DEVELOPMENT ASSESSMENT REPORT				
Application No.	DA/2020/0627			
Address	307 Nelson Street ANNANDALE NSW 2038			
Proposal	Construction of a terrace style dwelling-houses, each located on existing Torrens title allotments, and associated works including swimming pool and carport fronting Nelson Lane			
Date of Lodgement	05 August 2020			
Applicant	Candella Group Pty Ltd			
Owner	Mr Wallace H Chu Ms Sylvia A Attard			
Number of Submissions	13 Unique Objections			
Value of works	\$1,093,200.00			
Reason for determination at Planning Panel	Number of submissions exceeds officer delegation			
Main Issues	Incompatible with the existing Streetscape and Heritage Conservation Area; Insufficient information provided to ensure a tree located on the adjoining property will not be adversely affected; Amenity impacts to adjoining properties in relation to solar access and visual privacy; Breaches of the Building Location Zone and Side setback controls; Non-compliance with Site Coverage Development Standard.

Recommendation	Refusal			
Attachment A	Plans of Proposed Development			
Attachment B	Draft Conditions of Consent (if approved)			
Attachment C	Clause 4.6 Exception to Development Standards

Impact to solar panels

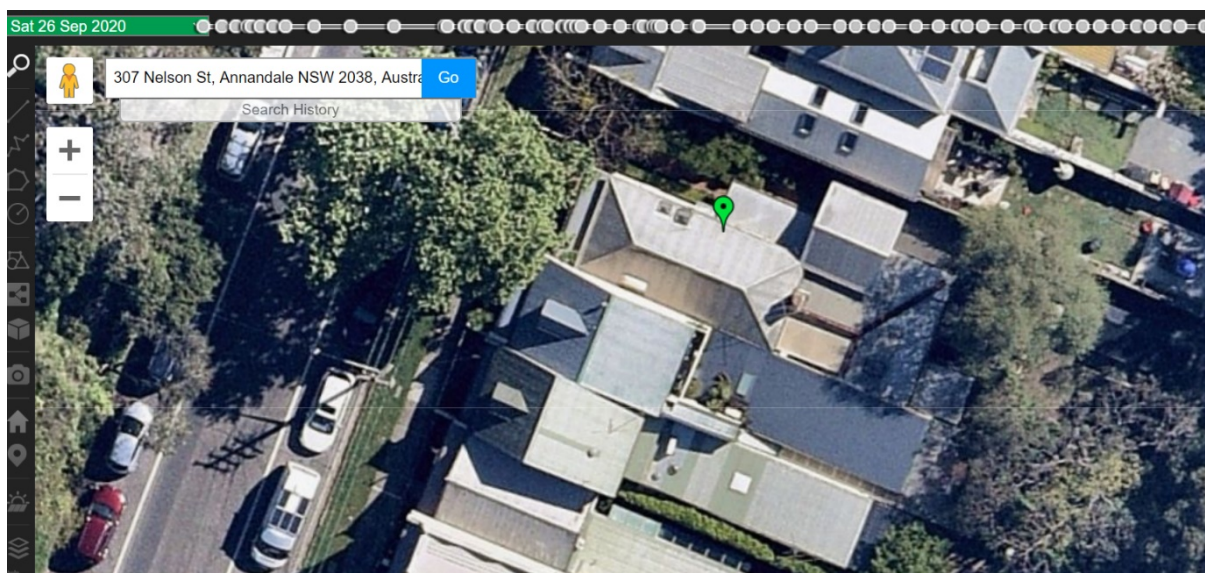
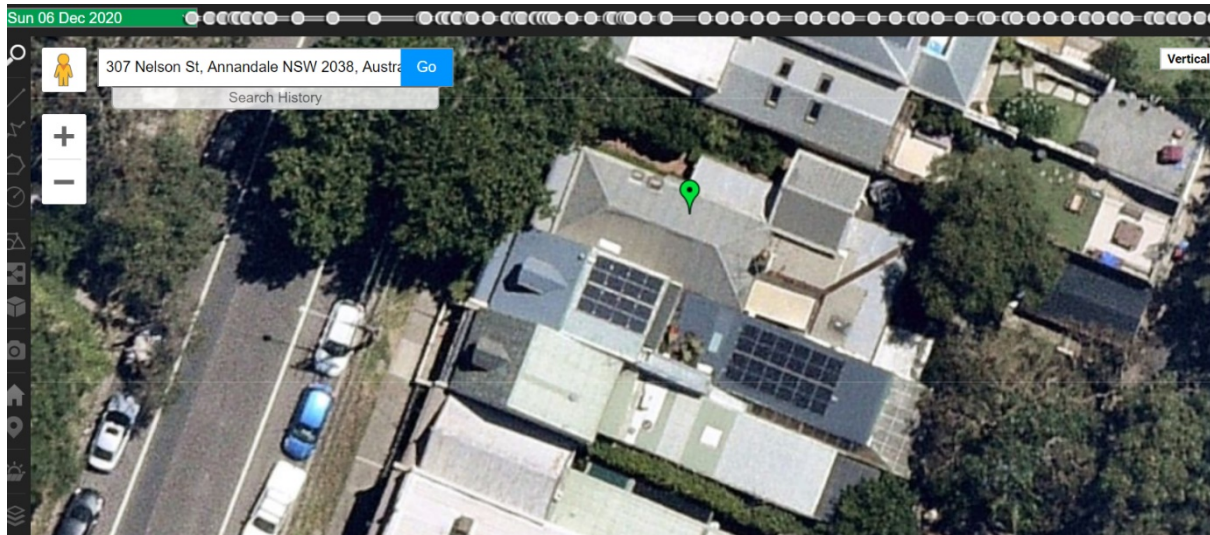
It is noted that solar panels were installed by No. 305 Nelson Street after the application was lodged (see images below from Near Maps)

As the proposed ridge heights of the southern dwelling will be at RL16.59, and the existing ridge height in the rear roof plane of the front section of 305 Nelson Street is between RL 17.08 and RL16.56, there will be no impacts to the solar panels at the front of the building. The solar panels at the rear section of the dwelling at 305 Nelson Street are located at a lower level and will be impacted by the proposed works. As the solar panels at the front of the dwelling will not be impacted by the proposed works and the solar panels were installed after the application was lodged, it is considered that on balance, the proposed impacts in relation to solar panels is acceptable. However, the application is recommended for refusal for other reasons outlined in this report.

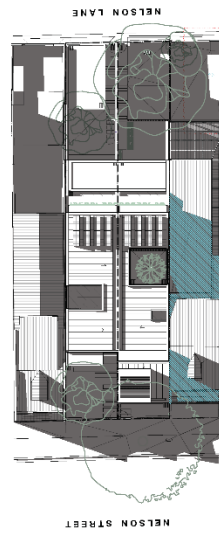
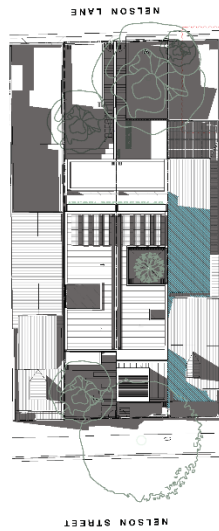
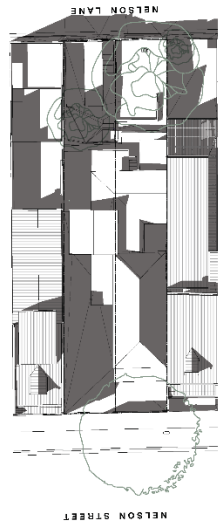
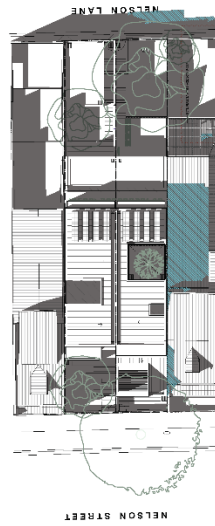
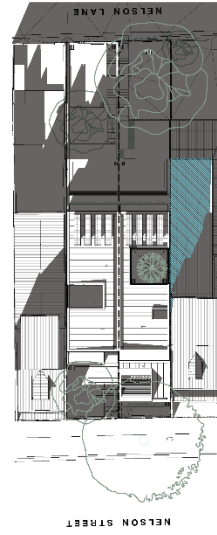
The most impacted property in this regard will be the southern-adjointing property at 305 Nelson Street. There will be no additional impacts to 303 Nelson Street at winter solstice between 9am and 3pm. Shadow diagrams in plan and elevation at hourly intervals during winter solstice have been provided. The shadow diagrams in elevation demonstrates that whilst there impacts to the first floor bedroom bedrooms, the proposed works will not have any additional impacts to the east-facing glazing of the living room, and therefore, complies with C12 of C3.9 – Solar Access. Solar access to skylights are not protect under C3.9 – Solar

The non-compliance is directly related to the significantly breach in the rear alignment of the Building Location Zone control at first floor level. As there is an obviously alternative solution, i.e. in reducing the extent of the rear alignment of first floor level, that would have minimised overshadowing, the proposal in its current form is not considered to be acceptable.
